REVISED RESPONSE TO REQUEST FOR ADDITIONAL INFORMATION

APR1400 Design Certification

Docket No. 52-046

RAI No.: 207-8247
SRP Section: 12.02 – Radiation Sources
Application Section: 12.2
Date of RAI Issue: 09/11/2015

Figure 1 MCR Charcoal Filter Shine Geometric Shielding Model

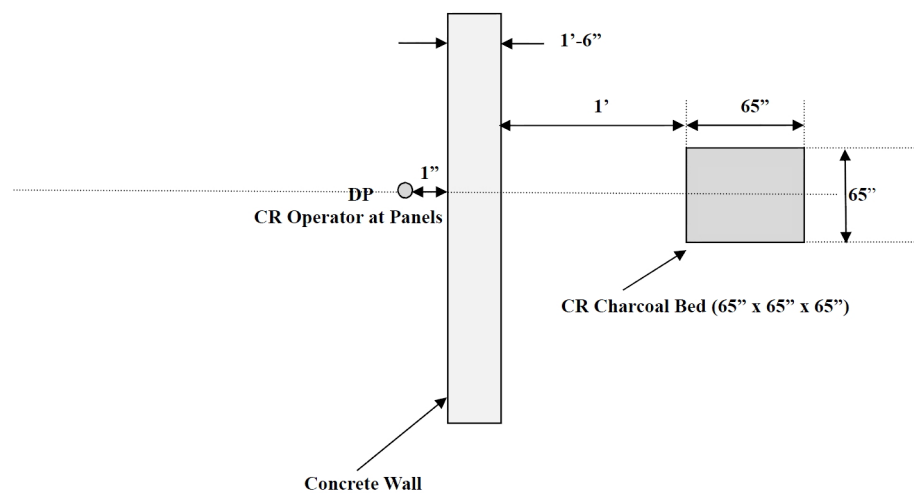
3. Update the FSAR to provide radioactive source dimensions and parameters for major post-accident source term components such as the shutdown cooling pumps and accident emergency control room ventilation filters and identify the locations of these components.

Dimensions for the MCR filter is provided in DCD Table 15.6-13 (3 of 3). The geometric model for the MCR charcoal filter shine dose calculation is shown in Figure 1. This model is based on the location of the MCR ACU and surrounding concrete shielding. In the shielding analysis, the charcoal tray of height 1.65 m is conservatively used.
